Hobson's Conduit Trust

Re CAMBRIDGE SOUTH EAST TRANSPORT ORDER

HOBSON'S CONDUIT TRUST STATEMENT OF CASE

**CAMBRIDGE SOUTH EAST TRANSPORT PHASE 2
TEMPORARY HOBSON'S CONDUIT CROSSING
GENERAL ARRANGEMENT**

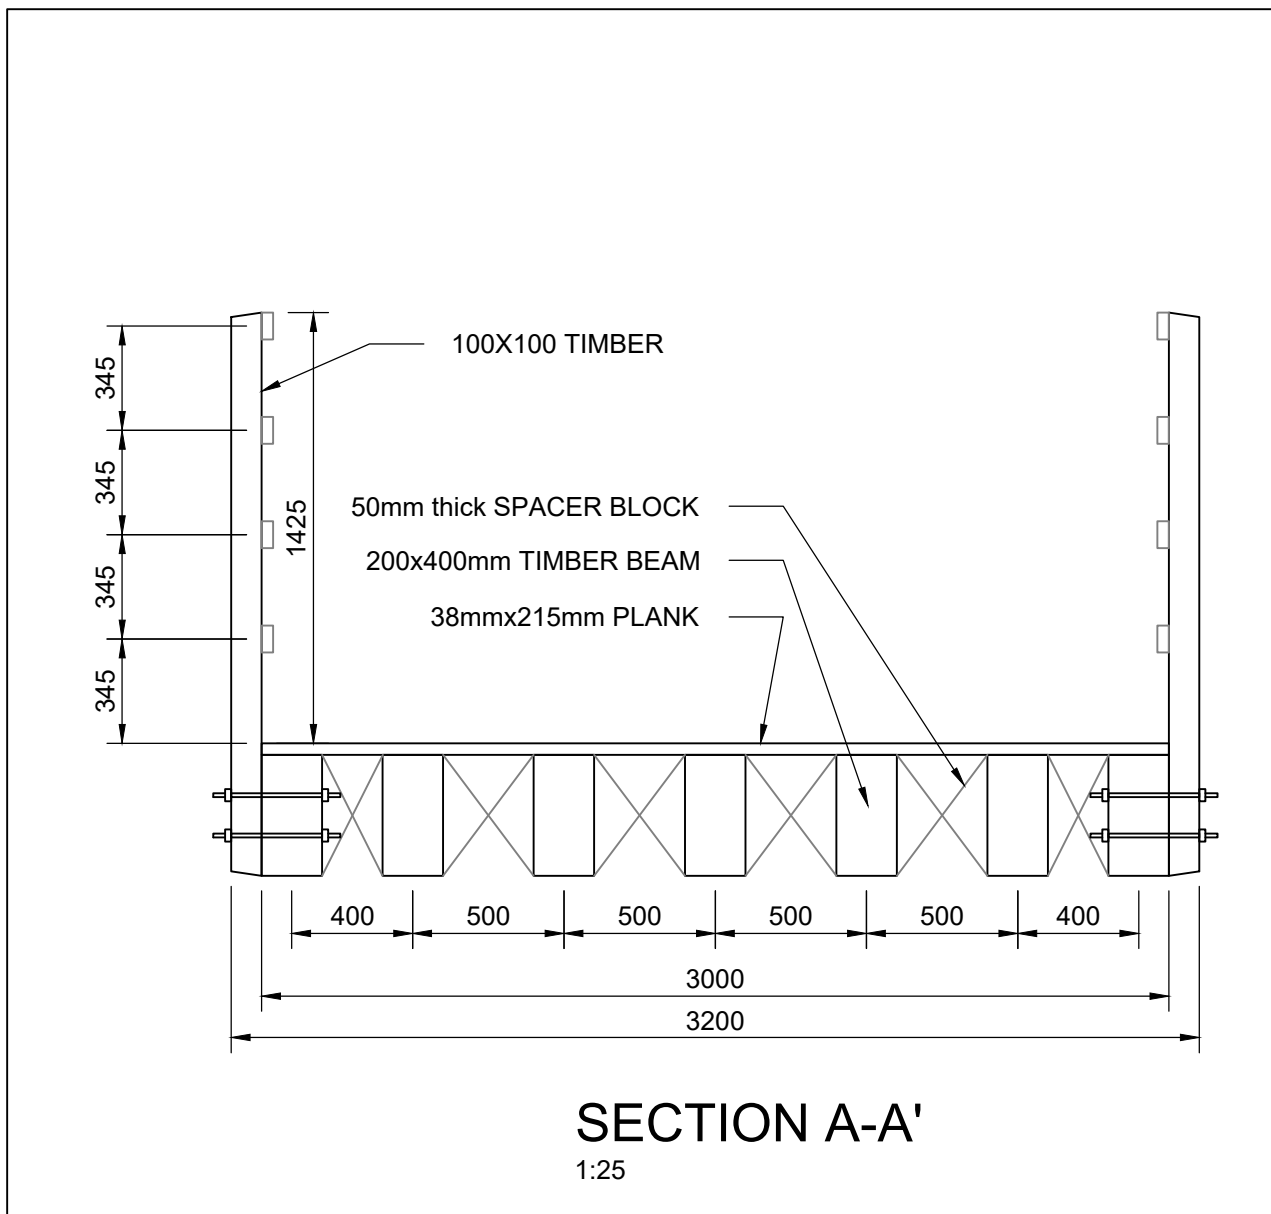
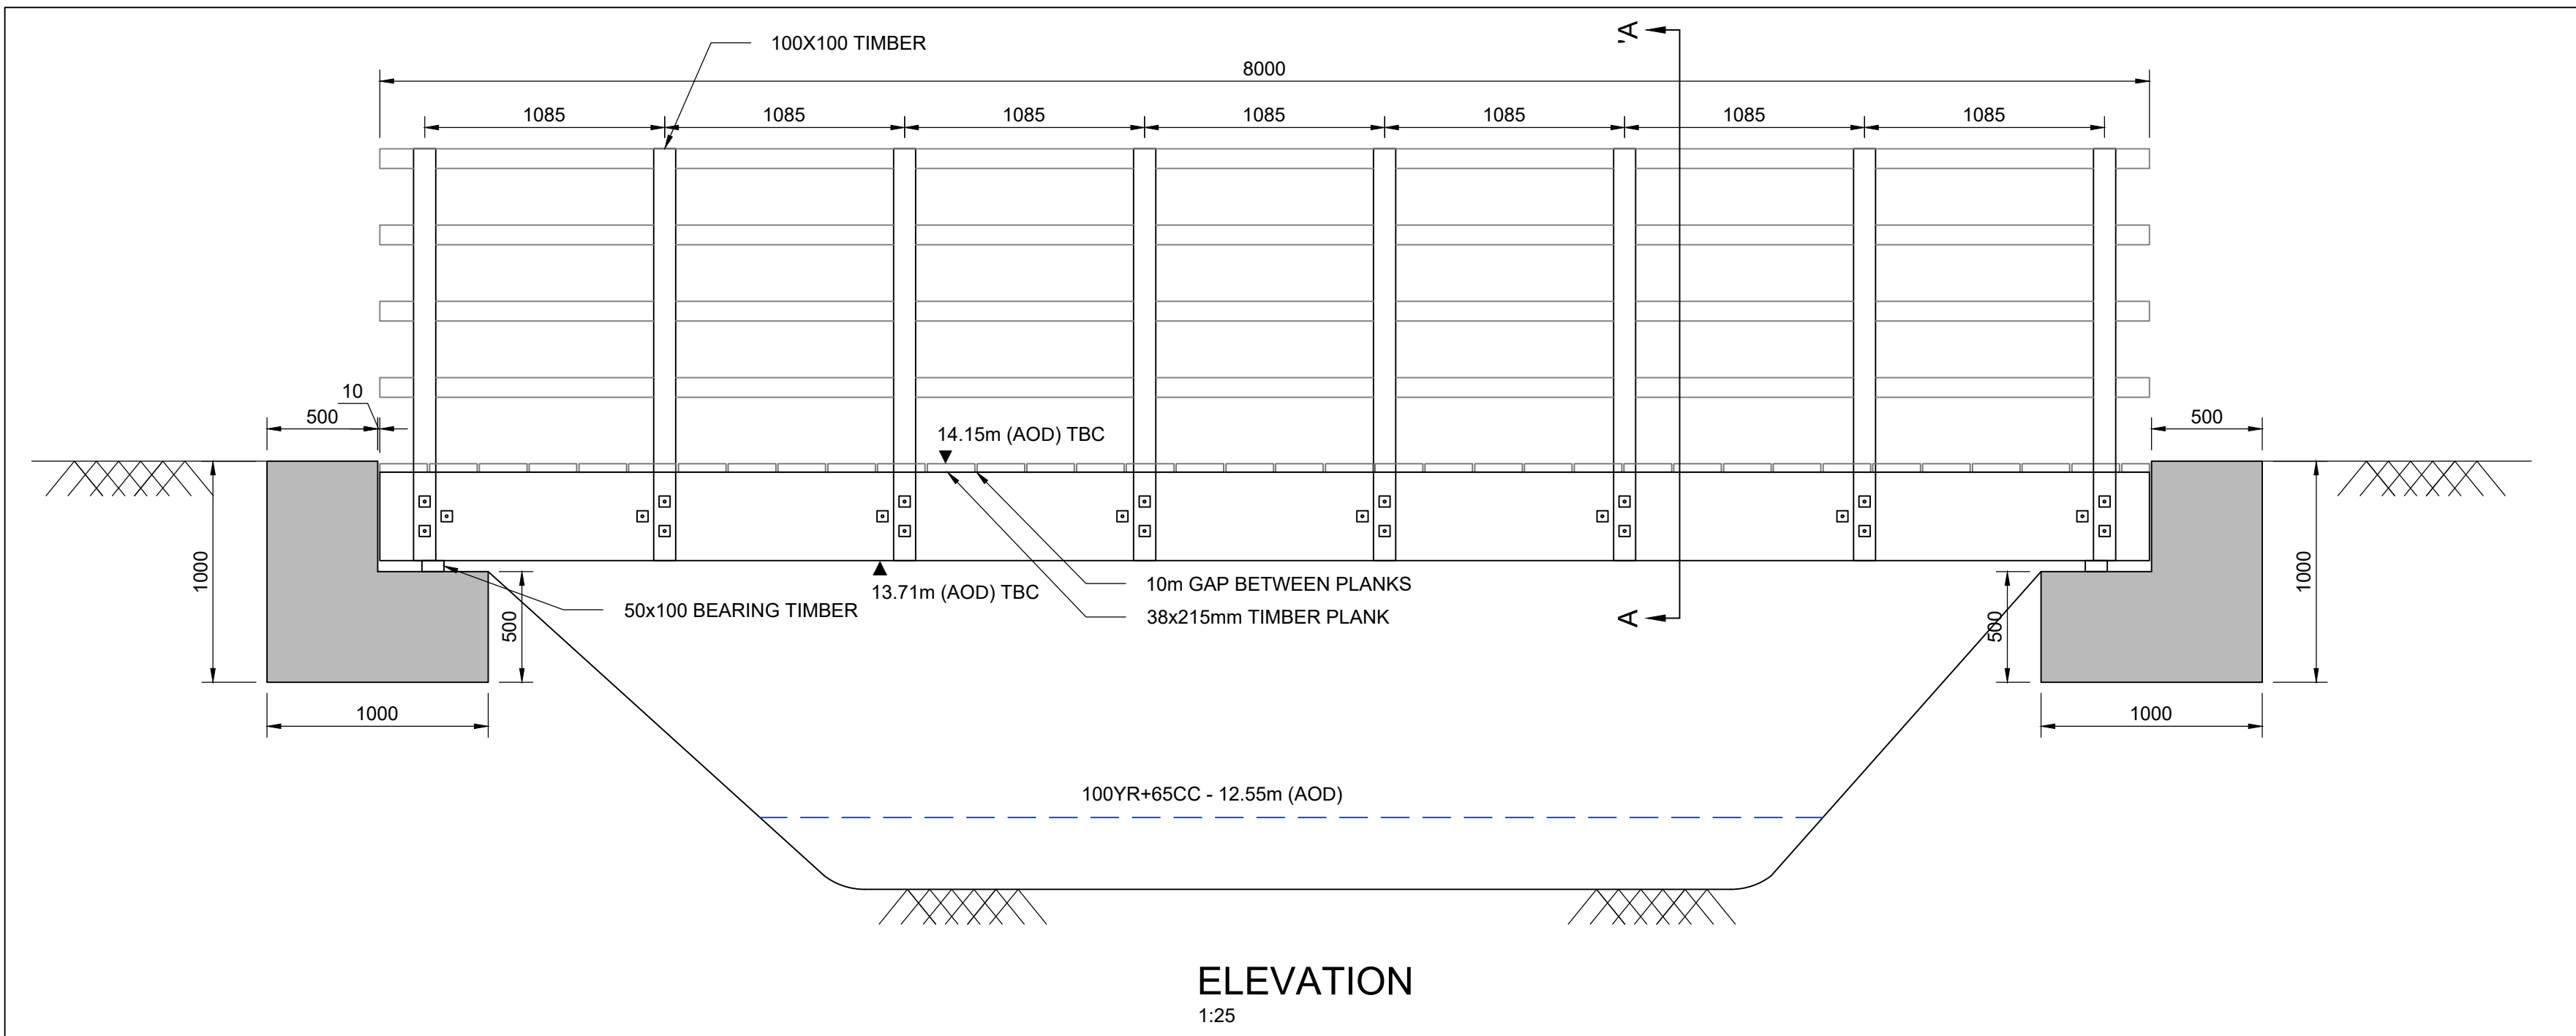
116. We have found no explanation of, description of or rationale behind a 'temporary structure' over the south end of Hobson's Brook marked on the plans where the spring
